PROJECT: 901 TROPHY HILLS (TOURNAMENT HILLS UNIT 3)

CITY OF LAS VEGAS		DATE:
INTER-OFFICE MEMORANDUM		April 25, 2011 AMS
TO: Land Development Services Department of Public Works		FROM: Albert Sung, P.E. Flood Control Project Engineer Department of Public Works
SUBJECT:	Drainage Study for:	COPIES TO:
	901 Trophy Hills (Tournament Hills Unit 3)	Wright One Source
Cross Streets:	NWQ of Summerlin Pkwy. & Rampart Blvd.	Robert Paul G. Trust
File Number:	F:\Depot\DSMemos\DS4521B.doc	Bart Anderson, P.E., DevCo
Parcel Number:	138-29-212-003; -004 & -005	
Zoning Action:	FMP-40979	
FEMA Flood Zone	YES	NO X
Proposed Storm Drain	YES	NO X

ADDENDUM #1 TO THE
UPDATE TO THE
TECHNICAL DRAINAGE STUDY
FOR TOURNAMENT HILLS – UNIT 3
A.K.A. 901 TROPHY HILLS

RE: UPDATE TO THE TECHNICAL DRAINAGE STUDY FOR TOURNAMENT HILLS – UNIT 3 – LOTS 3, 4, AND 5 A.K.A. 901 TROPHY HILLS
Job No. CN111029
DS4521

**FIGURE 7
DEVELOPED BASIN MAP**

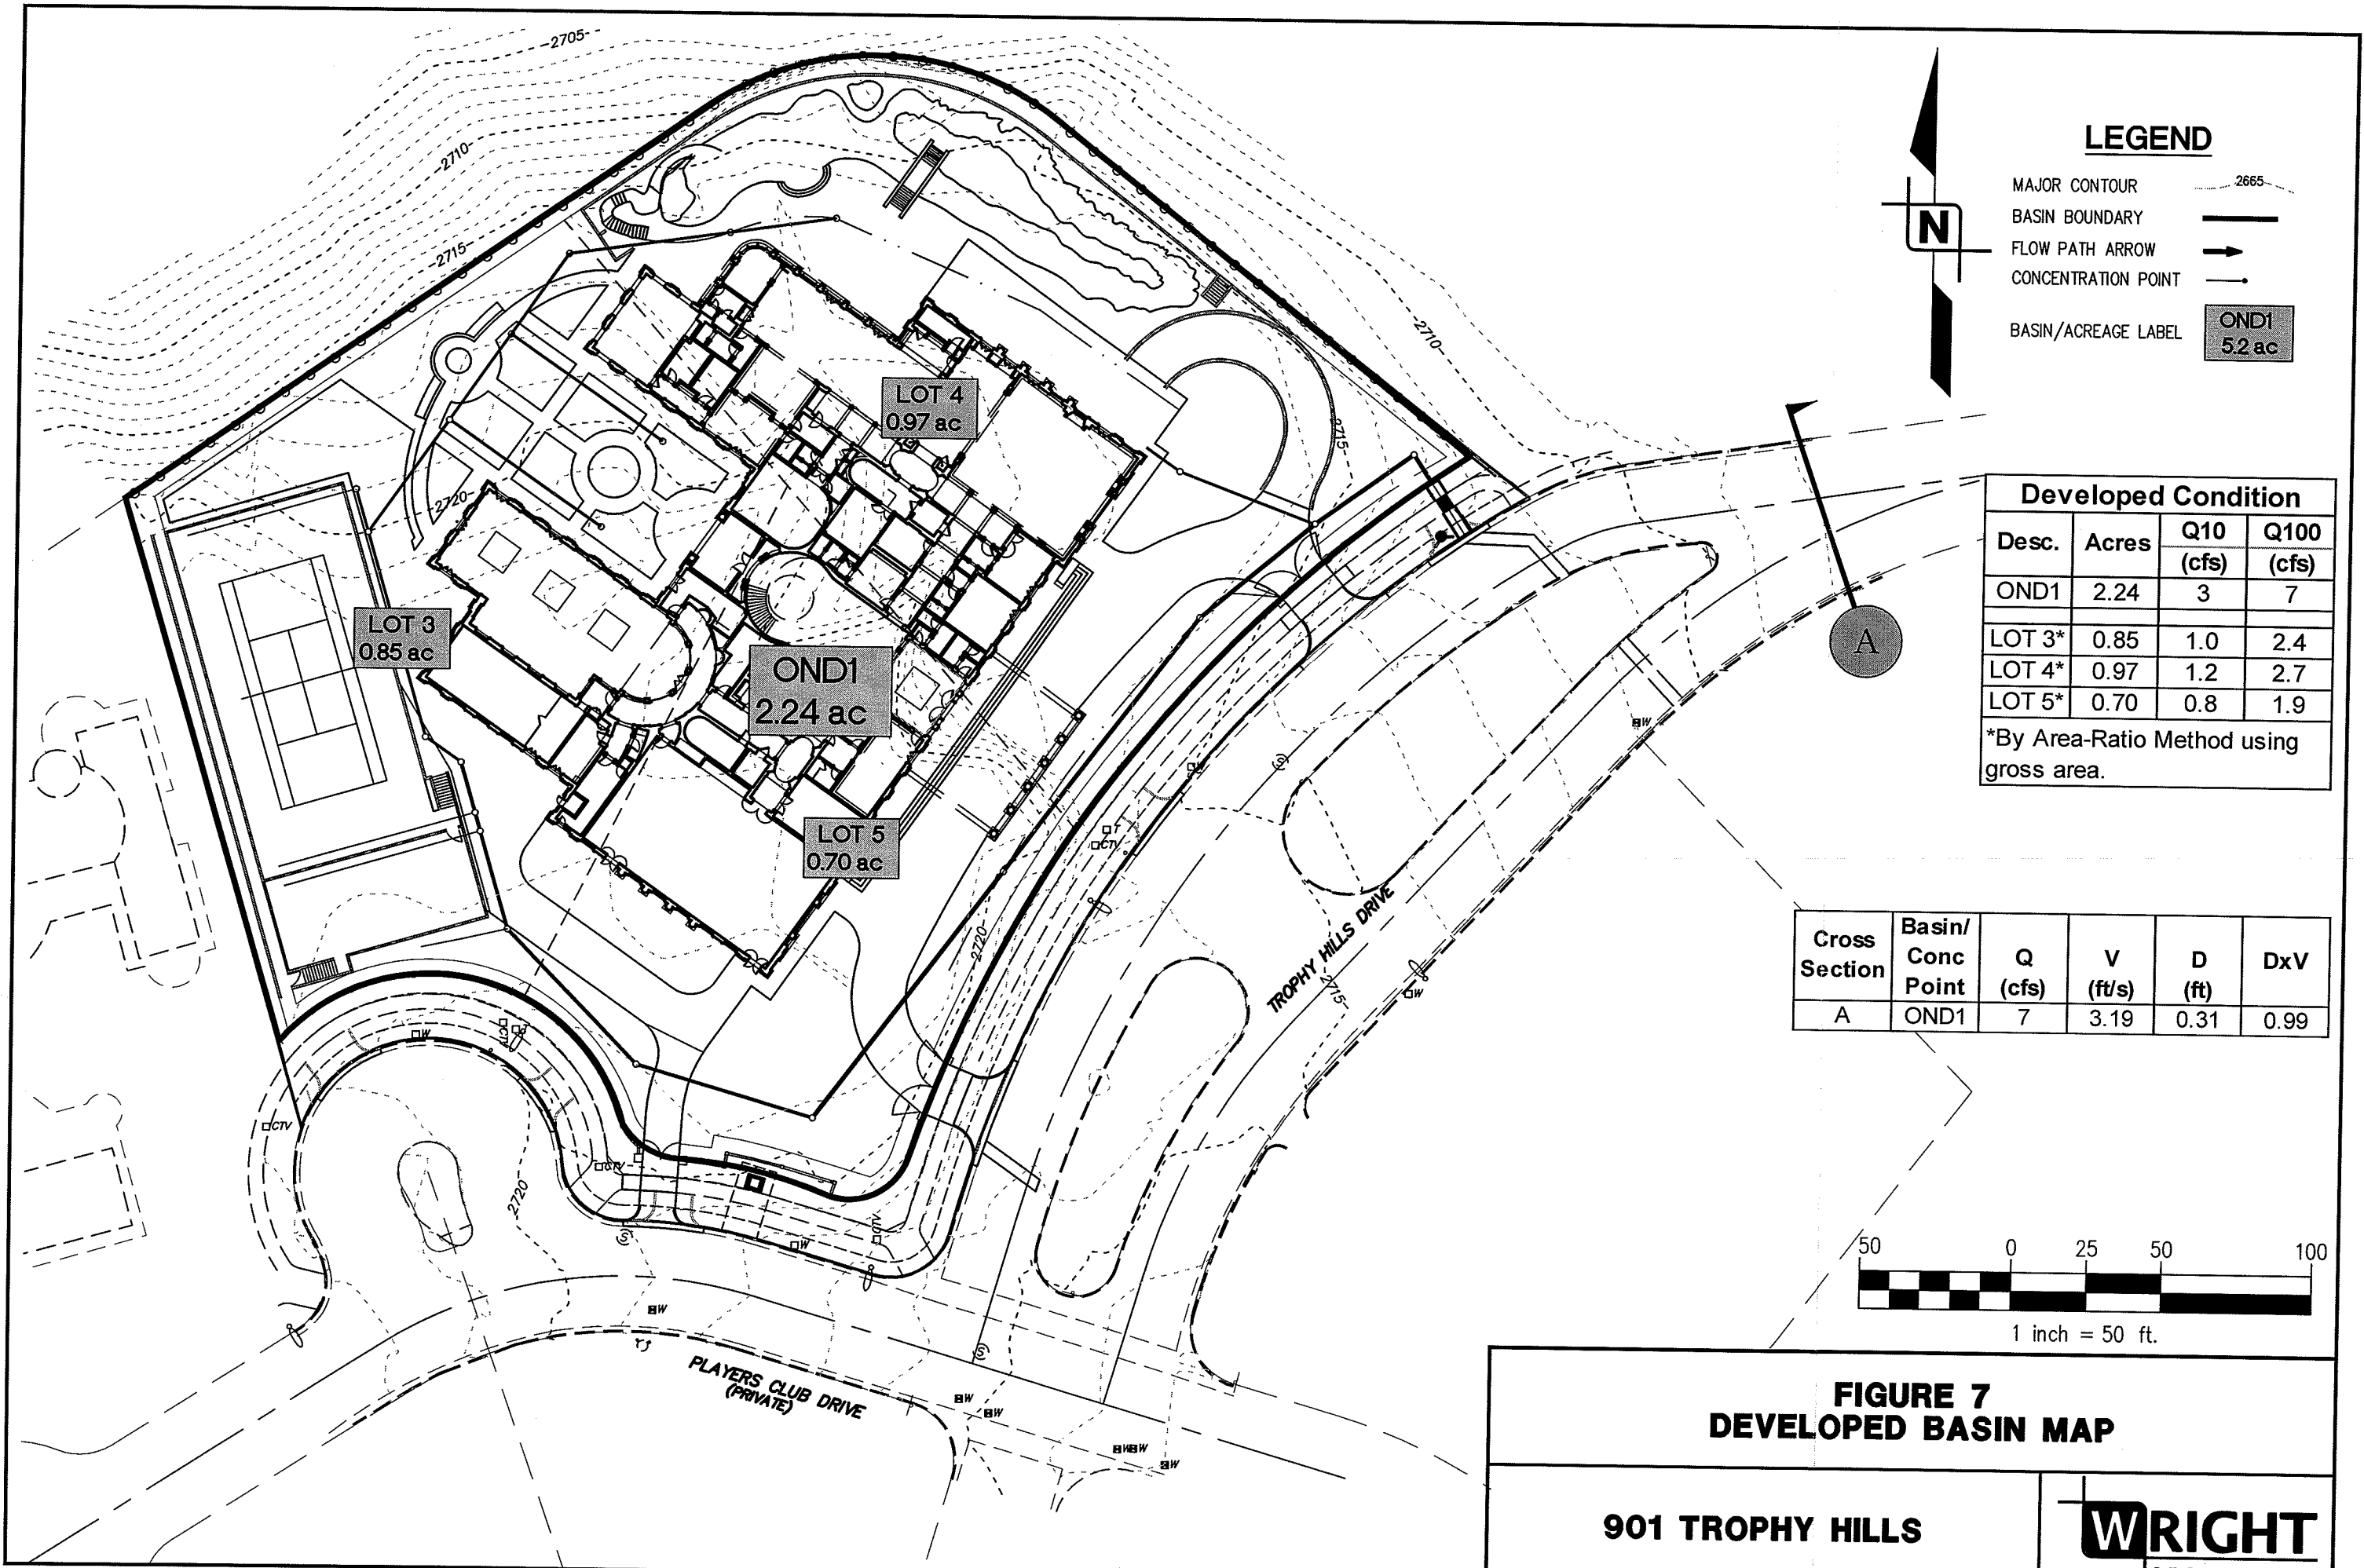
- 2. The project proposes to discharge concentrated flows through storm drain pipes at two distinct locations at the northwest property line to the adjacent golf course. Since this is concentrated flow which differs from the original sheet flow design. This may cause erosion and maintenance problem for the golf course owner/management. A notarized letter of acknowledgment or acceptance of the proposed design must be obtained from the adjacent golf course prior to the final approval of the drainage study. Also clarify whose responsibility is it for the maintenance of the storm drain pipes within the golf course.**

2. The project proposes to discharge concentrated flows through storm drain pipes at two distinct locations at the northwest property line to the adjacent golf course. Since this is concentrated flow which differs from the original sheet flow design. This may cause erosion and maintenance problem for the golf course owner/management. A notarized letter of acknowledgment or acceptance of the proposed design must be obtained from the adjacent golf course prior to the final approval of the drainage study. Also clarify whose responsibility is it for the maintenance of the storm drain pipes within the golf course.

RESPONSE: Unfortunately, the request for permission to discharge concentrated flow was denied by the golf course. The storm drain system has been revised to outlet to Trophy Hills Drive via a concrete flume with sidewalk underdrains. In the existing condition lot 4 drains to Trophy Hills Drive, while lots 3 and 5 drain to Players Club Drive. Due to the revision in the storm drain system a majority of the storm water from lots 3 and 5 will now drain to Trophy Hills Drive.

Hydrologic calculations have been completed for the project site and demonstrate that the 100-year peak flow increase to Trophy Hills Drive is approximately 4cfs. This minor diversion of flow will not negatively impact the downstream properties. The total site, a combination of lots 3, 4 and 5, produces 7cfs in the 100-year storm. A hydraulic cross section of Trophy Hills Drive has been provided. This section demonstrates that Trophy Hills Drive can adequately convey the additional flow at a flow depth of 0.31-feet. All necessary calculations and figures have been provided in the Appendix.

The revised storm drain system has been adequately sized to handle the 100-year storm flow. Emergency overflow paths have also been provided while still protecting the finished floor.
